## **Deim Subdivision** **SF2515**

### FINAL DRAINAGE REPORT

ALL TERRAIN ENGINEERING PROJECT NO: 24034

MARCH 2025

## EXISTING DRAINAGE MAP

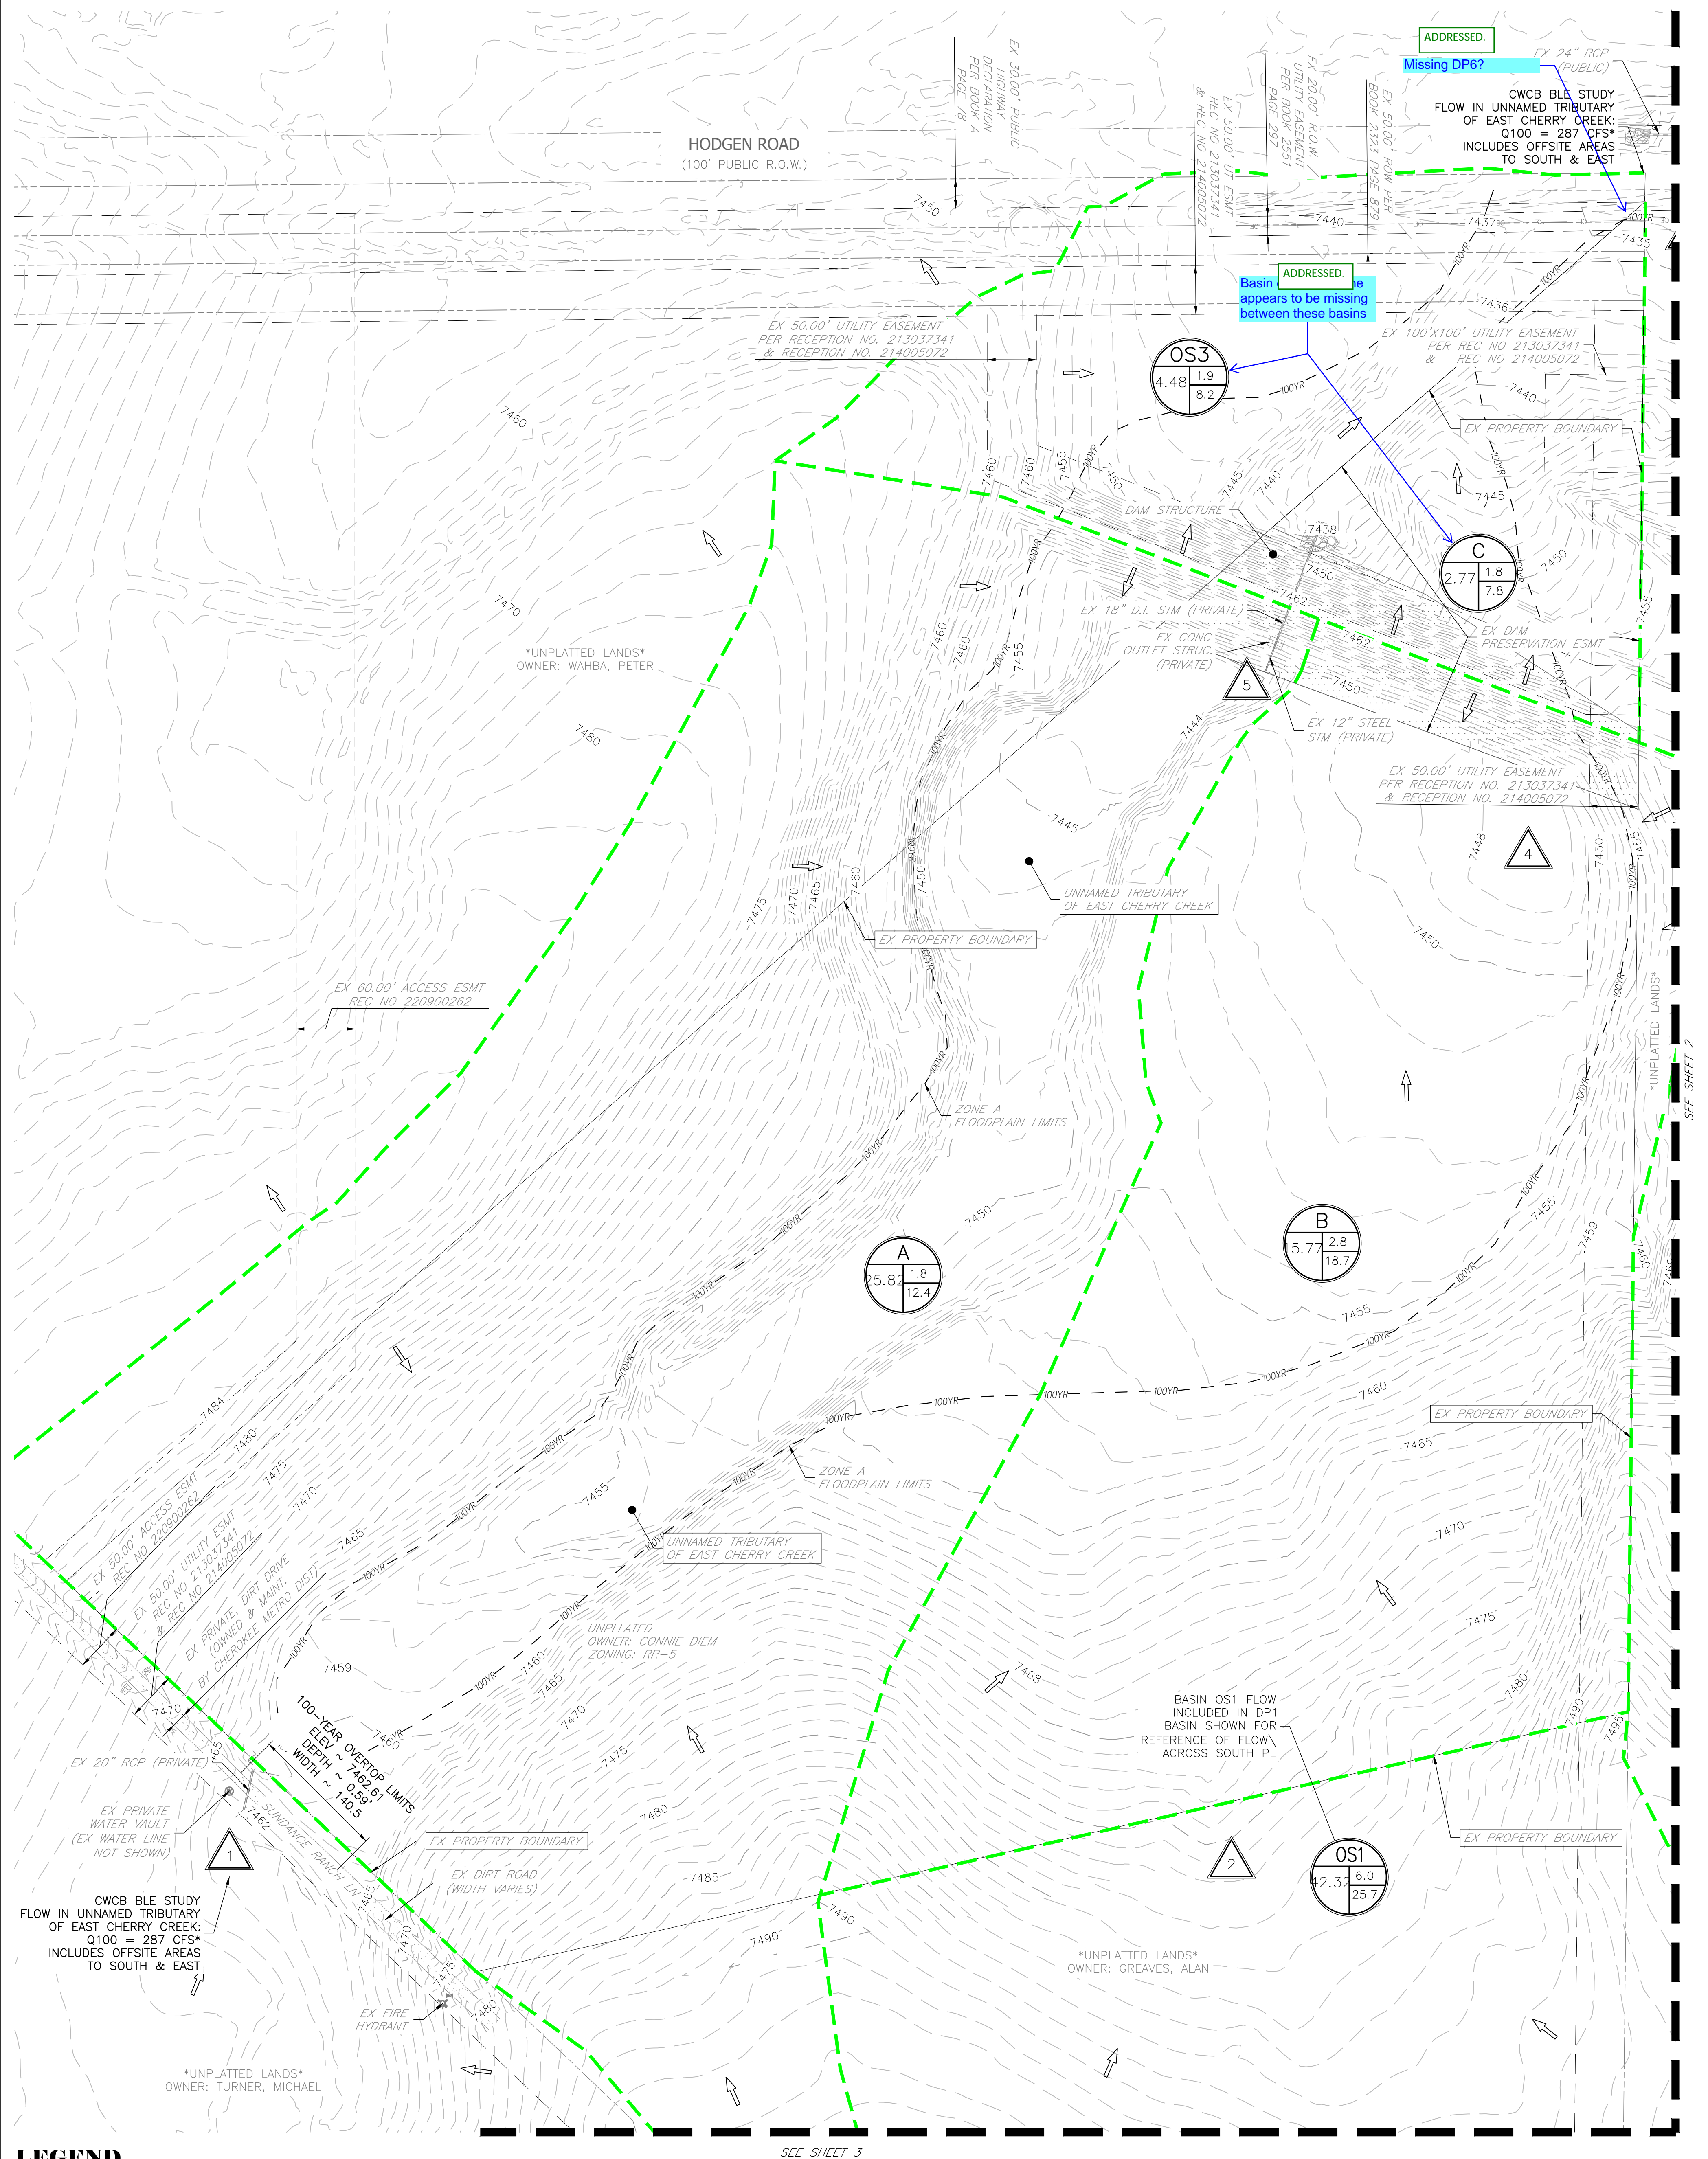
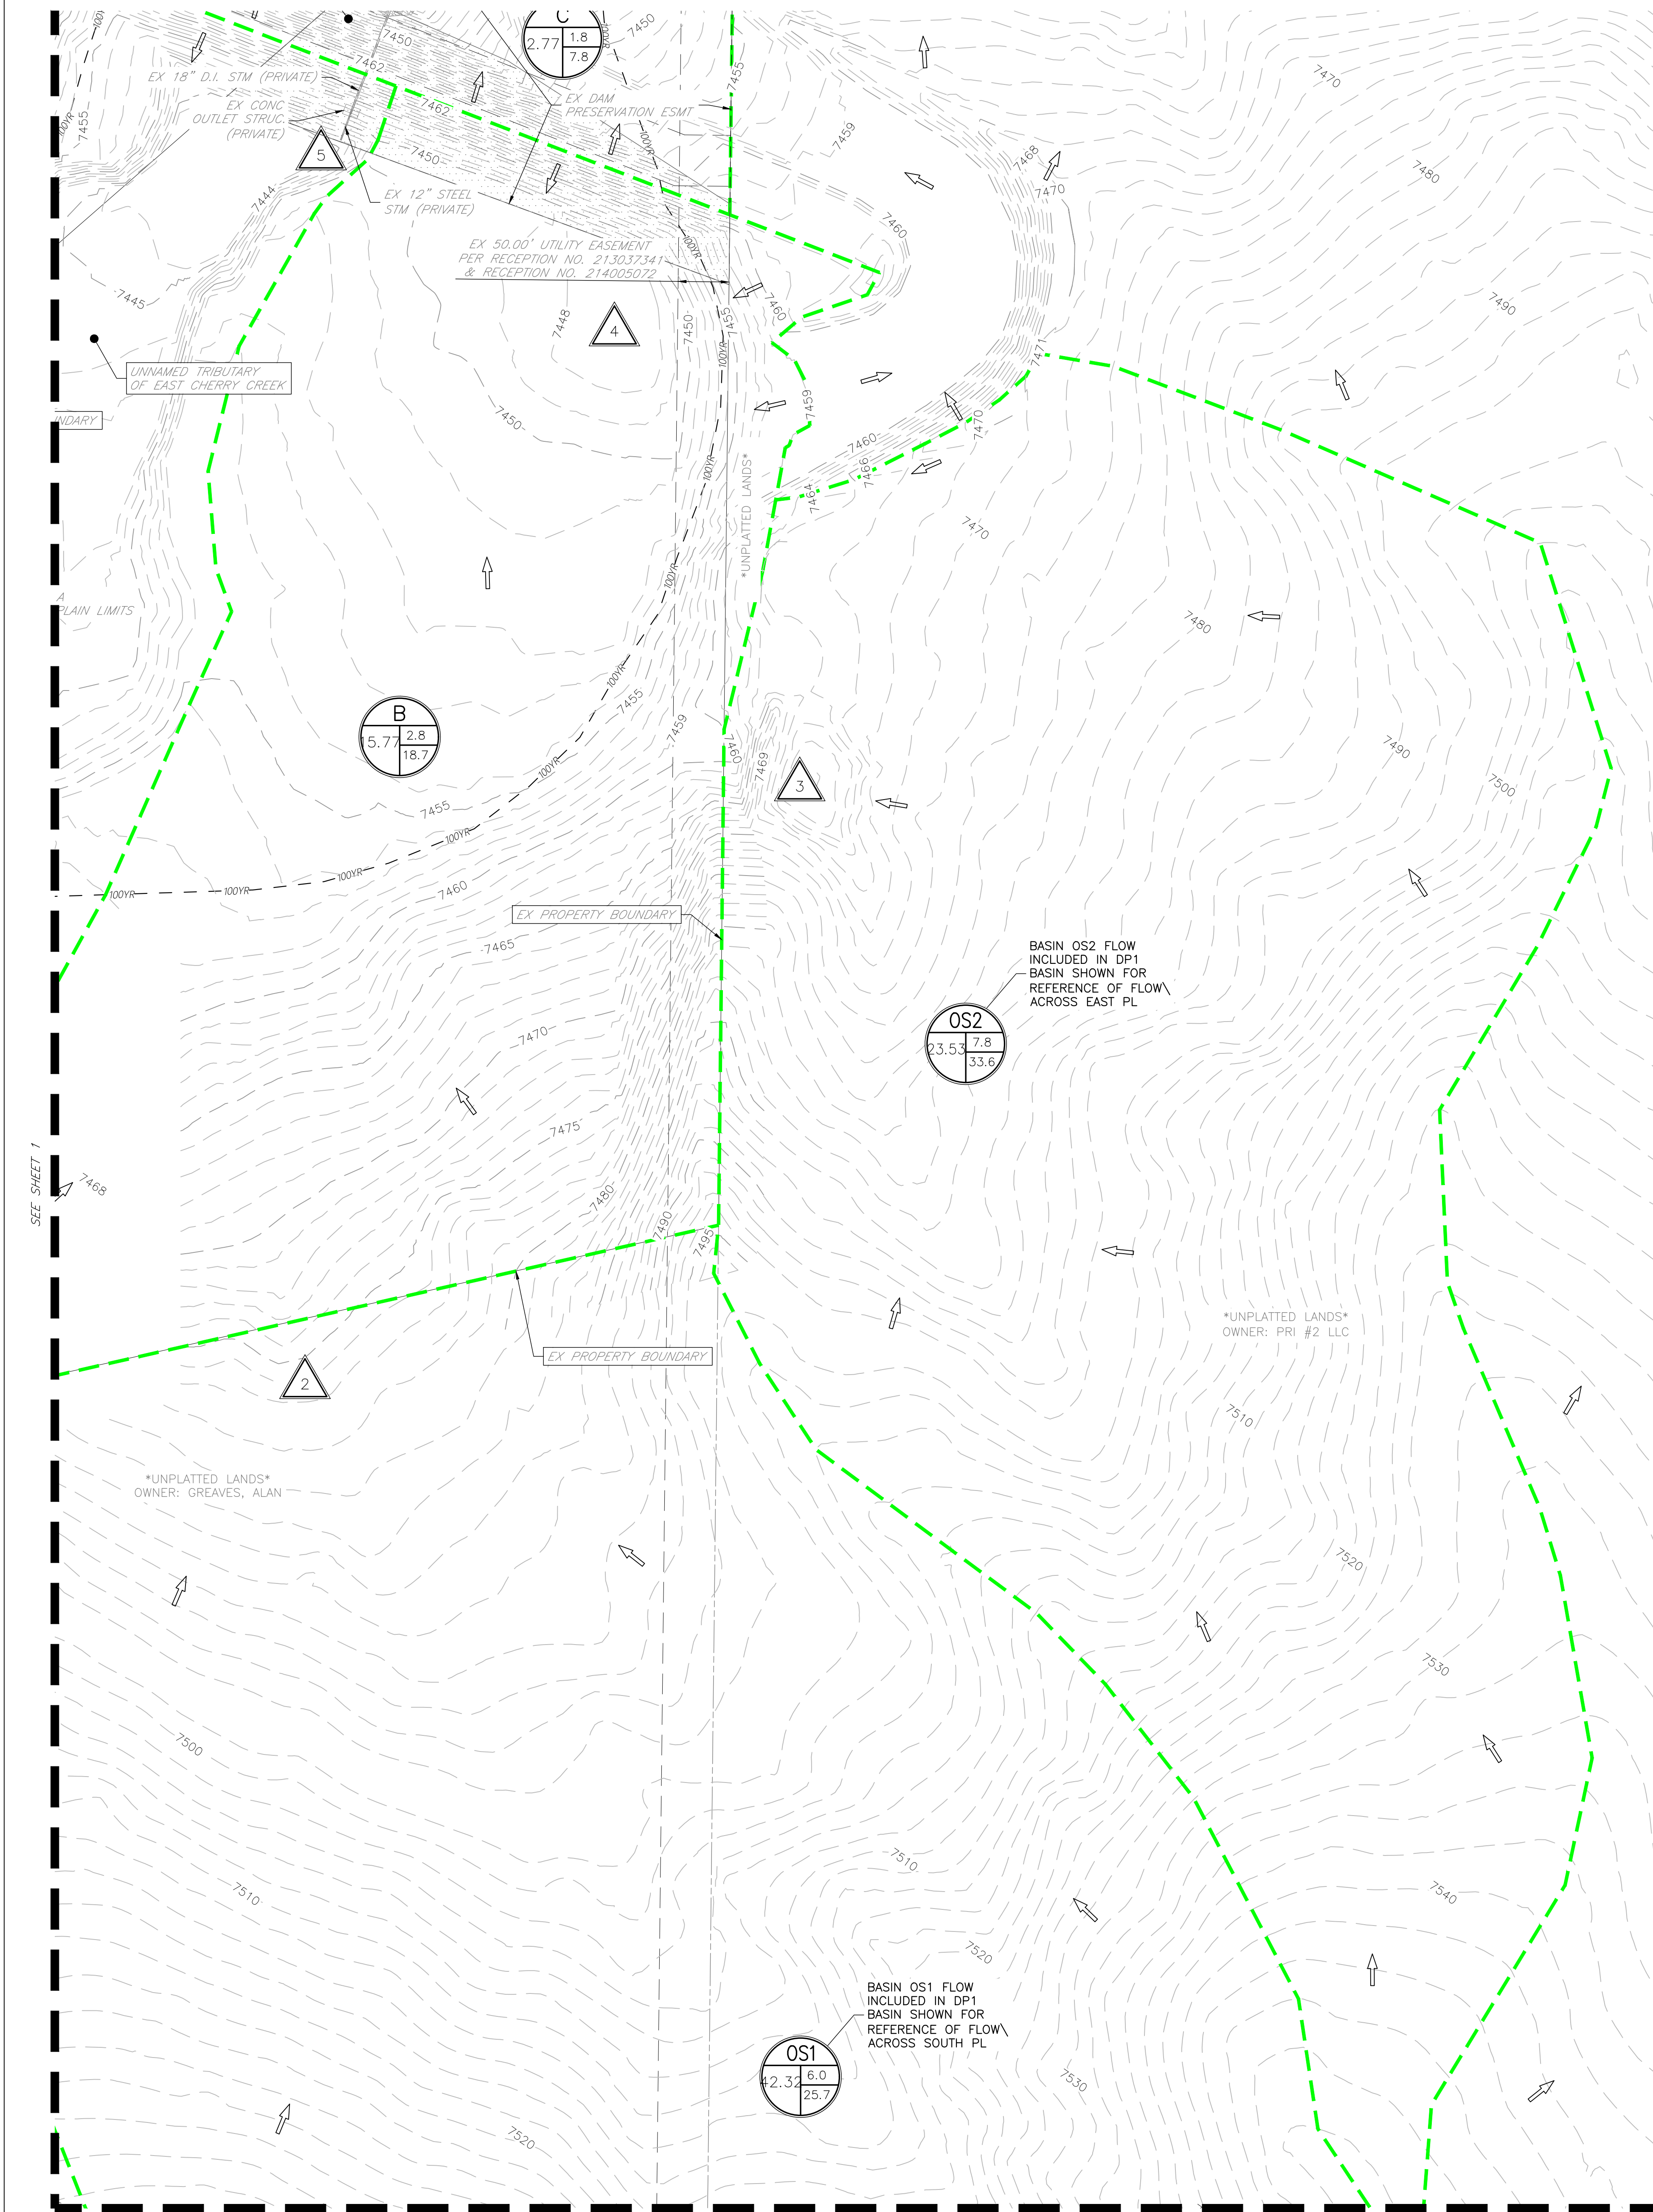
Please include an explanation of why DP1 and DP6 are the same design flow. Is the peak of the flows generated by the on site basins over before the peak of the off site flow onto the site?

show and label access road

ALL TERRAIN: THERE IS AN EXPLANATION OF THIS CONDITION IN THE BEGINNIGN OF THE EXISTING BASIN DESCRIPTION SECTION. ADDITIONALLY, THERE ARE NOTES ON THE DRAINAGE MAPS REGARDING.
